16 August 2021

NL191366.B13

Re: John Hunter Hospital Innovation Precinct – SSDA Civil Response to Submissions

Figure 12 – MUSIC Model Schematic

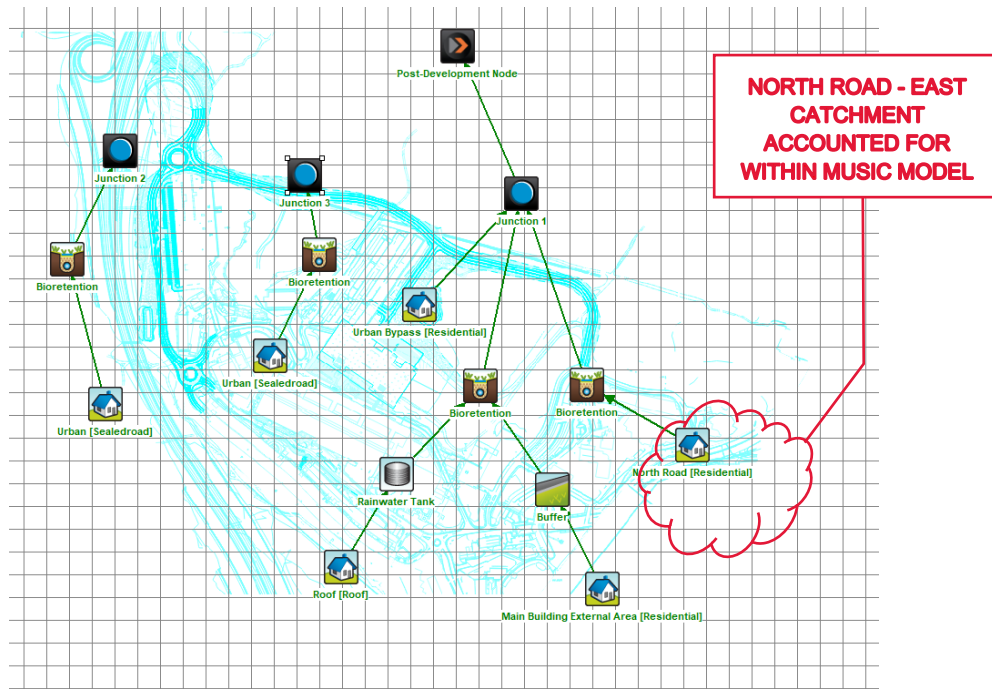
- The proponent should assess the impacts of the proposal on coastal wetlands in accordance with the Newcastle DCP Stormwater & Water Efficiency for Development Technical Manual (City of Newcastle 2017).

Northrop acknowledge that the original submission did not provide appropriate consideration of the developments impact on coastal wetlands and have revised the drainage assessment to address recommendation 8. A summary of the design modifications, including revised stormwater quality assessment is provided below. We note that Section 5.7 of the submitted SSDA drainage report has been revised (Figure and Table references are consistent with the SSDA report), the below information supersedes the corresponding information in Northrop's SSDA report. The predominant change to the water quality measures proposed for the site is the inclusion of a 50kL rainwater reuse tank in line with Council's deemed to comply requirements for coastal wetland catchments. Harvested roof runoff from the proposed ASB building is proposed to be reticulated to the water cooling towers.

The MUSIC model catchment area was broken down into sub-catchments to effectively simulate the proposed treatment measures along the treatment train. The proposed future road area was also included within the model to ensure any future works have been accounted for in the water quality provisions provided as part of the JHHIP project works. Whilst the future road has been considered in drainage calculations, the biofiltration basin is not being delivered as part of the JHHIP project and will be constructed in future stages in conjunction with the north road extension. A screenshot of the MUSIC model can be seen below in Figure 12. The catchment areas included only the proposed works.

Figure 1 – 1% AEP flood extent

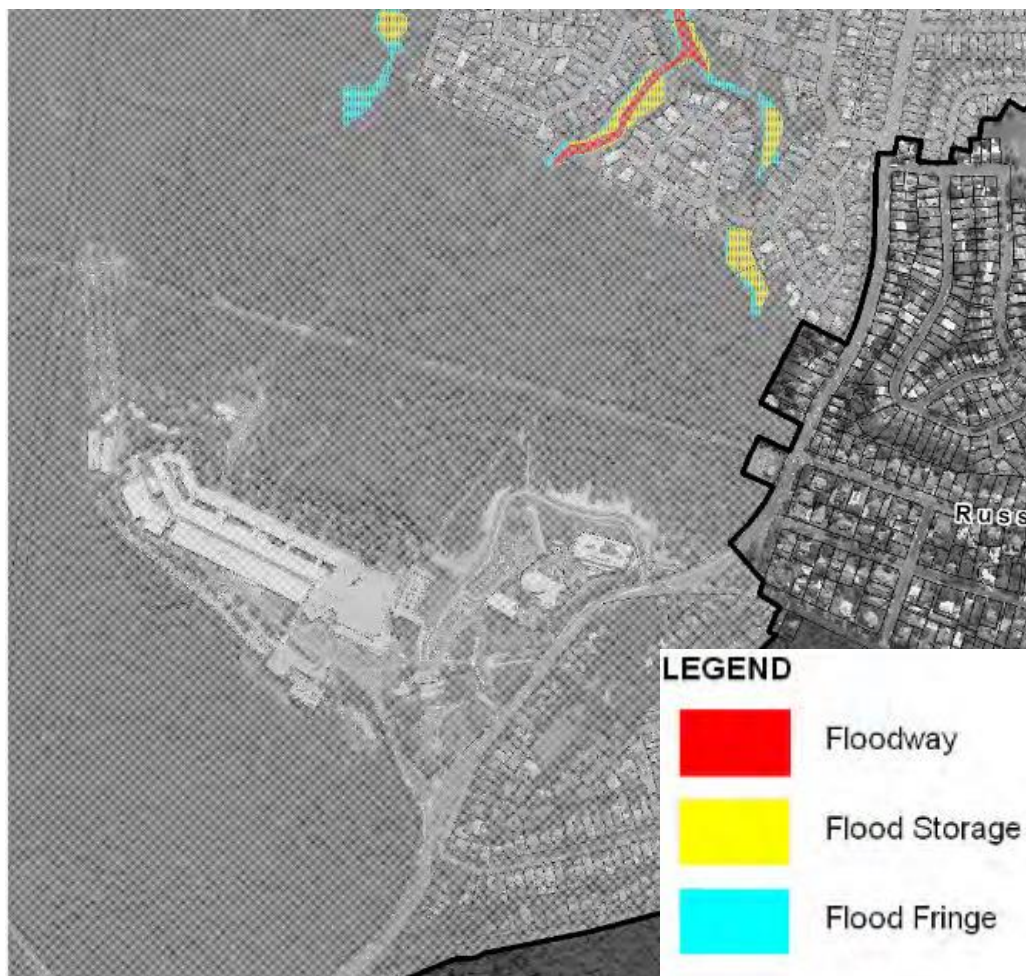
NCC Comment 2 – Flood Management.

- Due to the sensitivity of downstream receiving waters, flood mitigation measures are to be considered as part of the proposal to mitigate downstream flood impacts

Figure 1 below taken from Draft Newcastle Floodplain Risk Management Study Map Series 4 – 1% AEP Flood Impact Categories (BMT WBM 2012) indicates the site is not affected by the 1% AEP storm event. Furthermore, given the topography of the area the site is outside of the flood planning areas which would be defined as the 1% AEP plus 500mm.

As the site is not located within a flood planning area and is not flood affected by regional catchment flooding it is our understanding that a regional catchment assessment is not required by the DCP and as such has not been undertaken as part of the submission. Given the site is seen to be only affected by localised flooding (i.e. site runoff) the drainage measures being implemented as part of the development, i.e. onsite detention, stormwater diversions and new drainage infrastructure are seen to be sufficient to appropriately manage the localised flood risk found on site.
